MEMORANDUM

Department of Building and Planning

DATE: March 1, 2022

RE: Kendall Toyota - Proposed Internally Illuminated Wall – Determination of
Architectural Harmony

Illumination Study

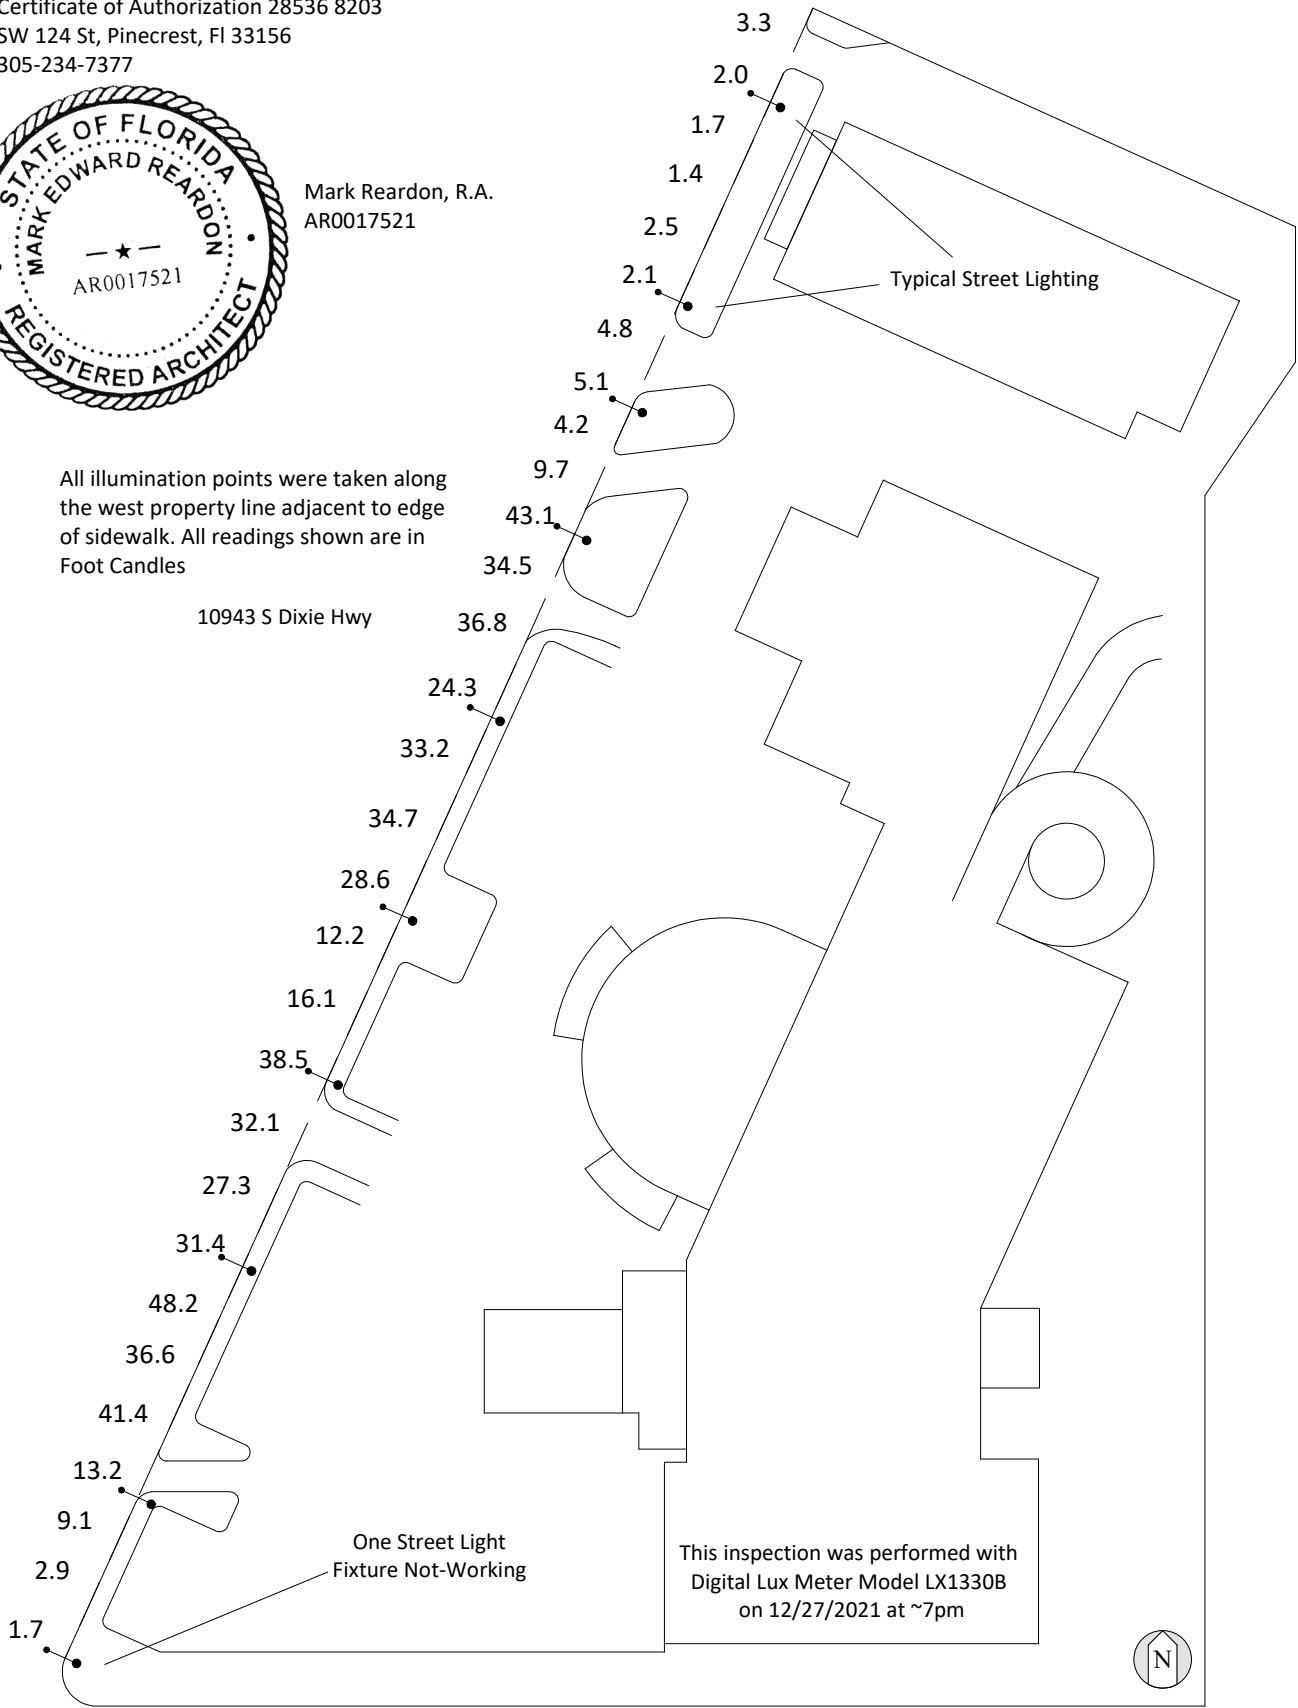
An Illumination Study, completed by Allied on December 27, 2021 (attached) confirms existing lighting levels at the Kendall Toyota property line adjacent to Pinecrest Parkway to be as high as 48.2 foot-candles, or 96.4 times greater than otherwise permitted by code today. Additionally, a recent field inspection completed by the Building and Planning Department has confirmed that several of the existing lights on the subject property are not shielded and are causing glare. The proposed illuminated wall may result in the addition of more lighting intensity to the site that is already non-conforming with regard to existing unshielded lighting fixtures and intensity of lighting at the property line. Recent photographs showing existing lighting conditions on the subject property are provided on pages 9 and 10 of this report.

Division 5.20 – Non-conformities. Internal illumination of the existing glass wall would likely add lighting to the exterior of the property that would likely increase the existing degree of non-conformity, contrary to Division 5.20 of the Village’s Land Development Regulations. The Land Development Regulations limit lighting at the property line to a maximum of 0.5 foot candles. Pending code compliance questions notwithstanding, an Illumination Study completed by Allied on December 27, 2021 (attached) confirms existing lighting levels at the property line adjacent to Pinecrest Parkway to be as high as 48.2 foot-candles, or 96.4 times greater than otherwise permitted by code today.

The proposed internally illuminated wall would likely result in the addition of more lighting intensity to the site that is already non-conforming in terms of glare and intensity of lighting at

the property line. Please refer to the photographs included above and to the attached Illumination Study.

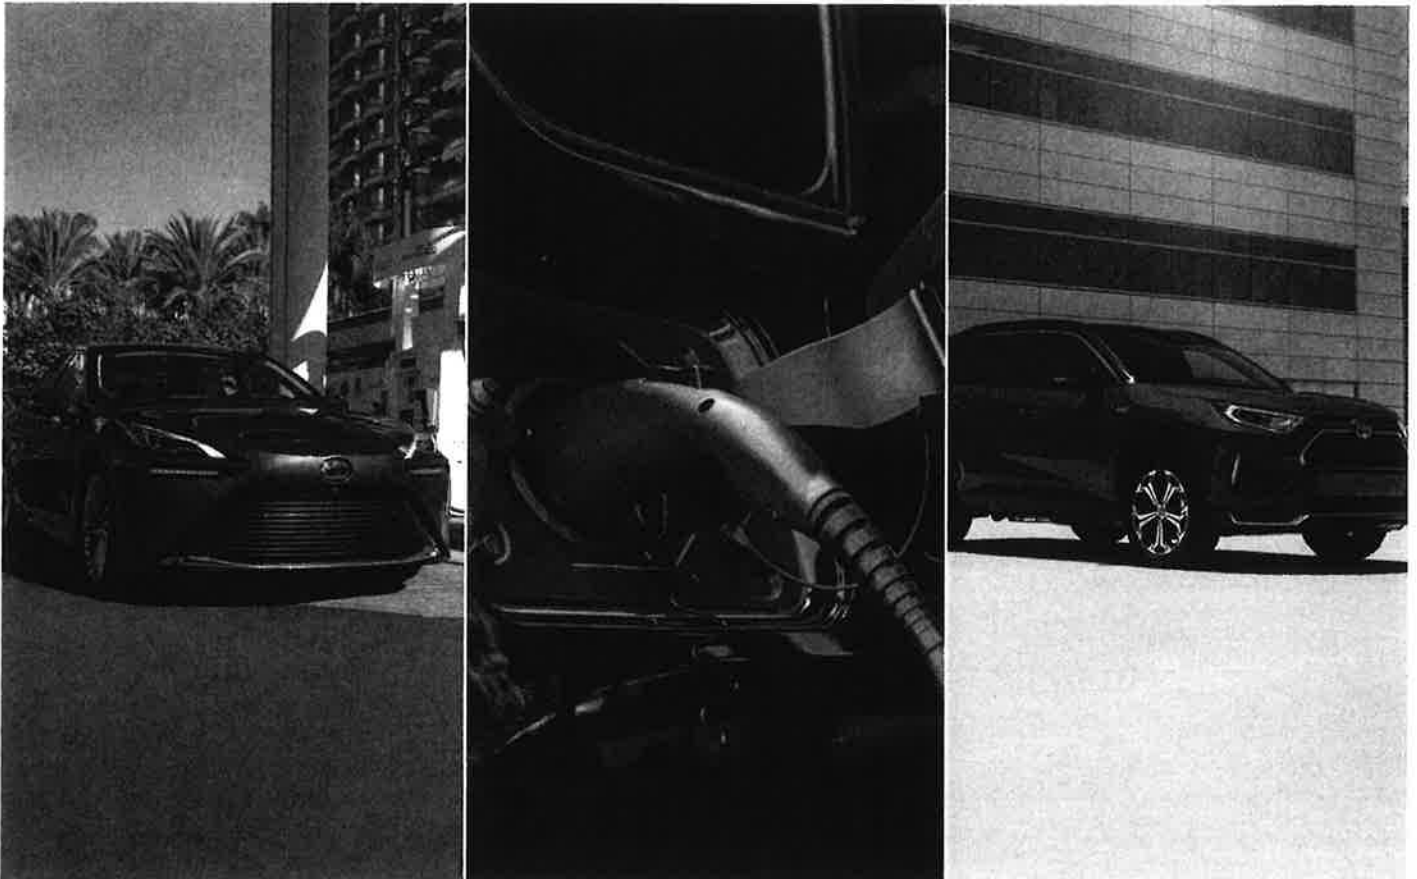
2. *Please add a dimmer switch and switch details and specifications to the proposed lighting circuit to allow consistency with the architectural design standards of the Village's Land Development Regulations and Pinecrest Parkway (US1) Corridor Plan.*

3. *Per Development Order 2017-0718-3, the proposed lighting plan, when revised, will be submitted to the Administrative Official (Village Manager) for review.*

The Toyota entrance portal is a proprietary design. A dimmer switch is neither available or possible. We kindly ask for clarity and specificity of the pertinent architectural design standards of the Village's Land Development Regulations and Pinecrest Parkway (US1) Corridor Plan. Without criteria to satisfy, we respectfully request that this matter be escalated to the Village Manager and/or Village Council for further review.

Attached, please find the proposed lighting plan for submittal to the Village Manger for review. See Exhibit B.
